Project Building Name / # Lloyd Center Block "G" North Wall Maintenance & Repair - Addendum
Project Address or Location 2201 NE Lloyd Center

permit
revision
transmittal

Project Name: Lloyd Center Block 'G'
North Wall Maintenance &
Repair - Addendum

Copies:	Date:	Item:
4	04.25.19	Permit Revision #01 – Repair Addendum Includes (4) sheets: Revised Sheets G1.0 & A4.1 New Sheets A3.2 & S2.2

G1.0

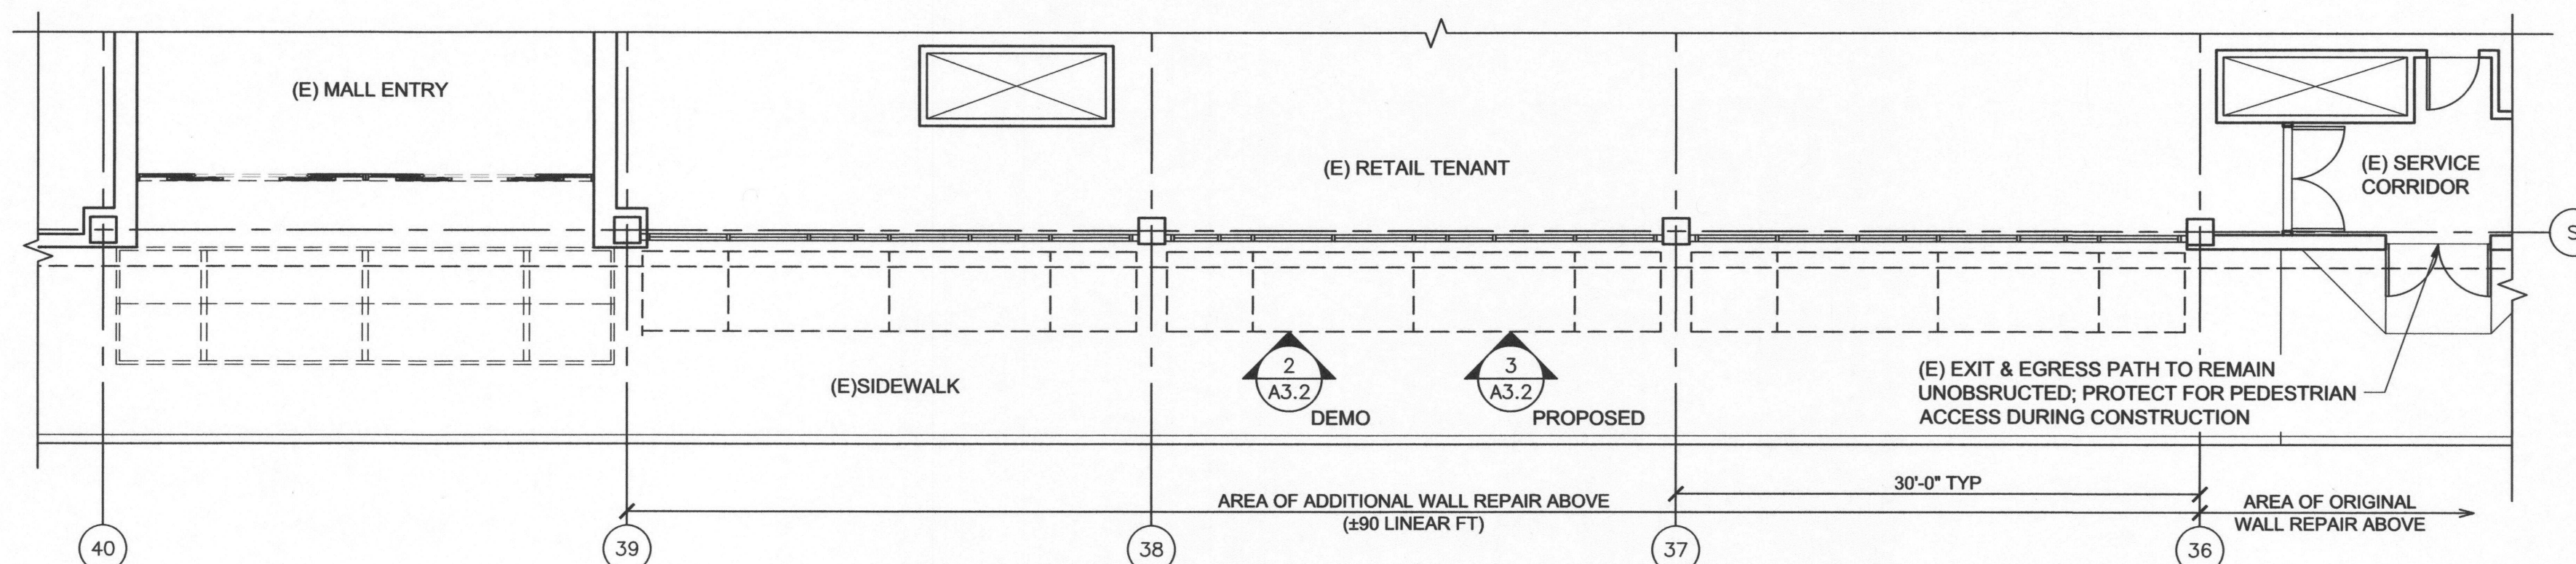
01 PERMIT REVISION #01: APRIL 26TH, 2019
-Added additional wall area to repair

**REPAIR ADDENDUM:
PLAN, ELEVATIONS
& DETAILS**
A3.2

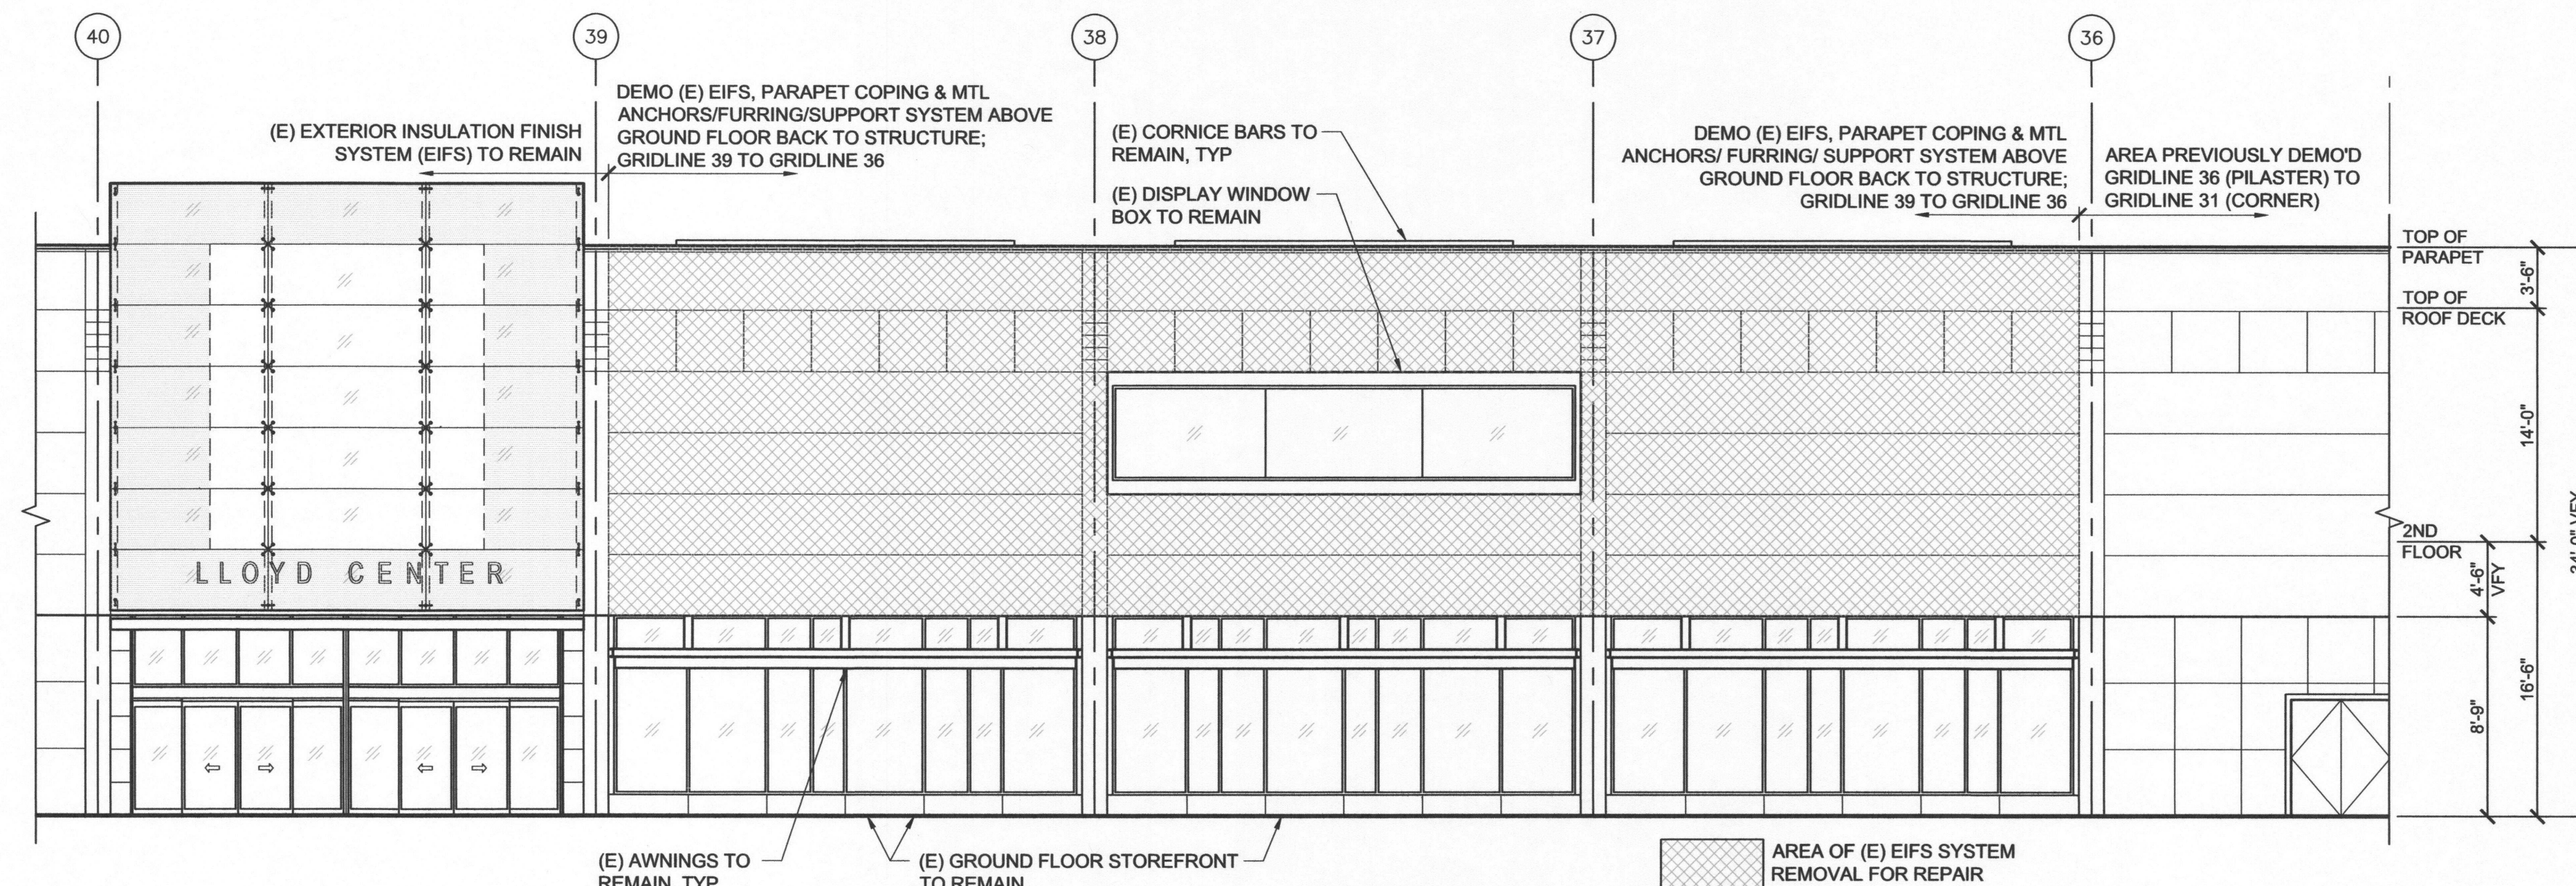
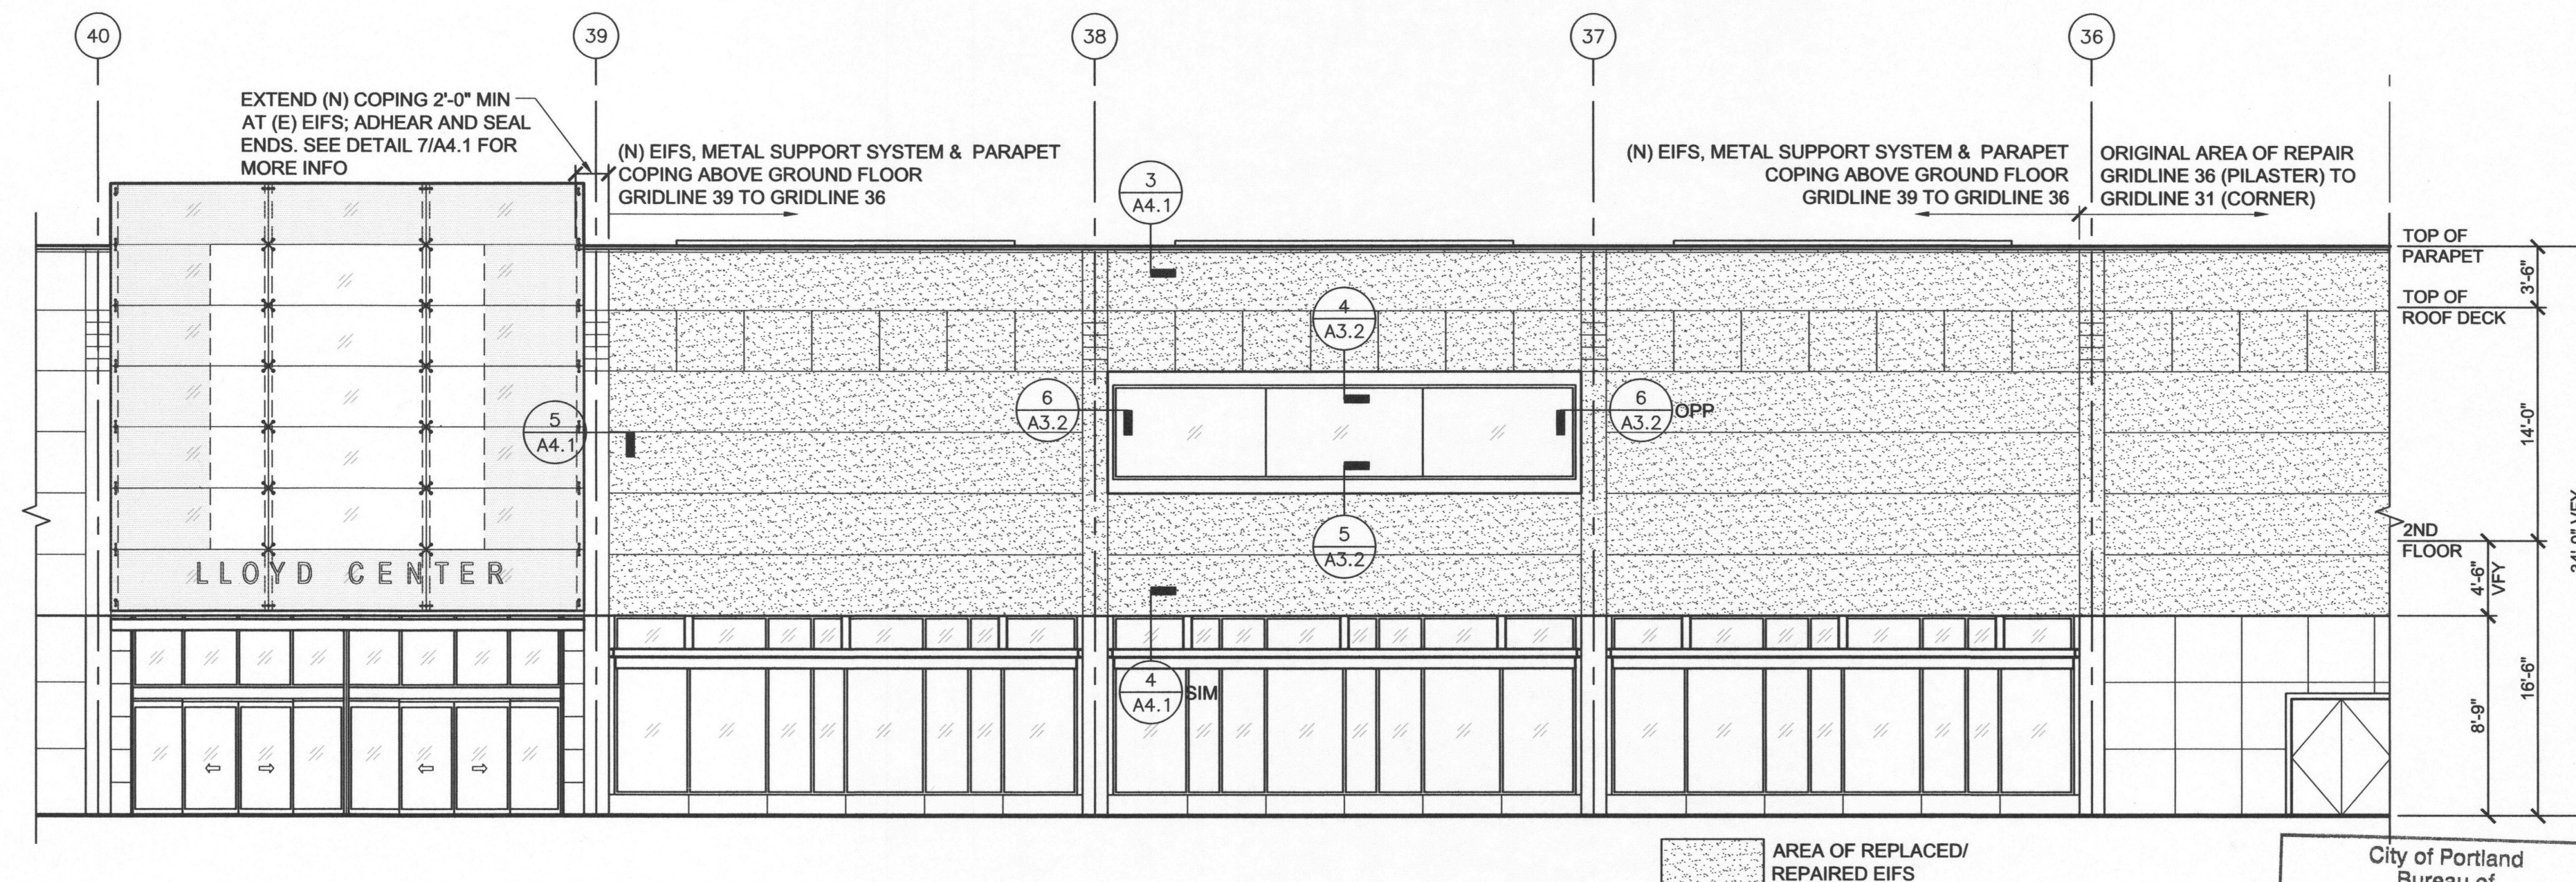
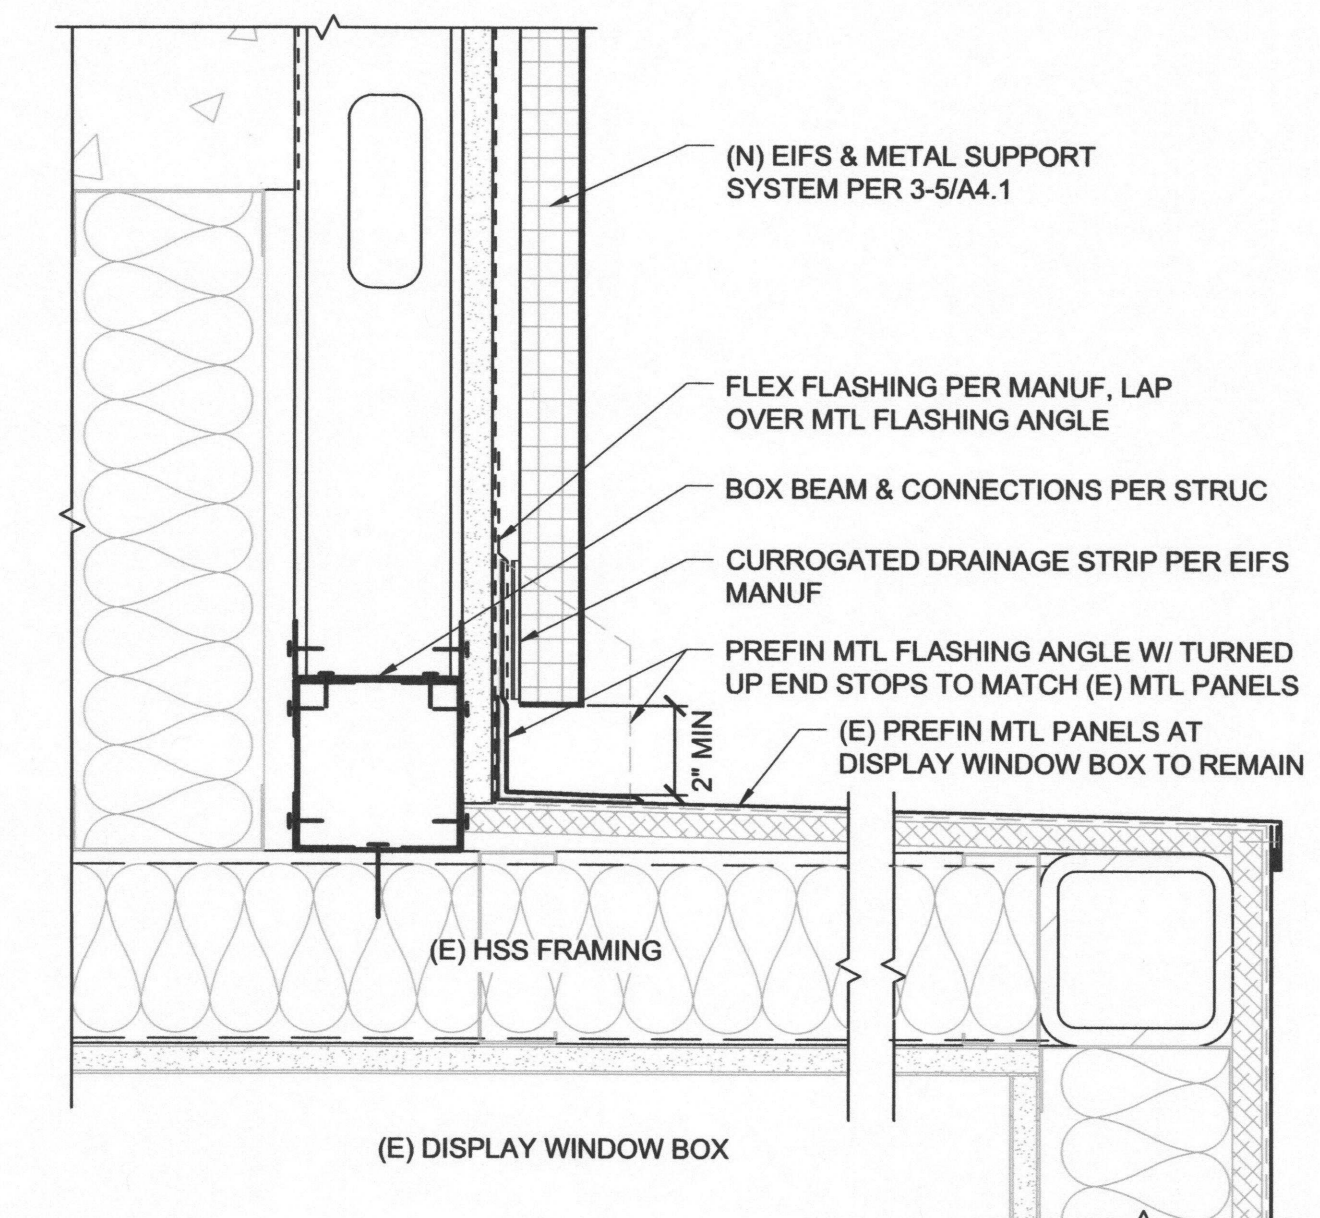
Due to additional damage from water intrusion, it will be necessary to demolish and repair an additional 90 linear feet of the existing EIFS and framing substrate on top of the base scope of work in our original Permit #19-104170-000-00-FA. The additional work occurs between Gridline 36 & Gridline 39 at the Block 'G' North Wall.

See attached for 4 revision sheets depicting the area of work, and additional architectural/structural details for work around the existing Ulta Tenant Display Window Box as well as minor revisions for constructability.
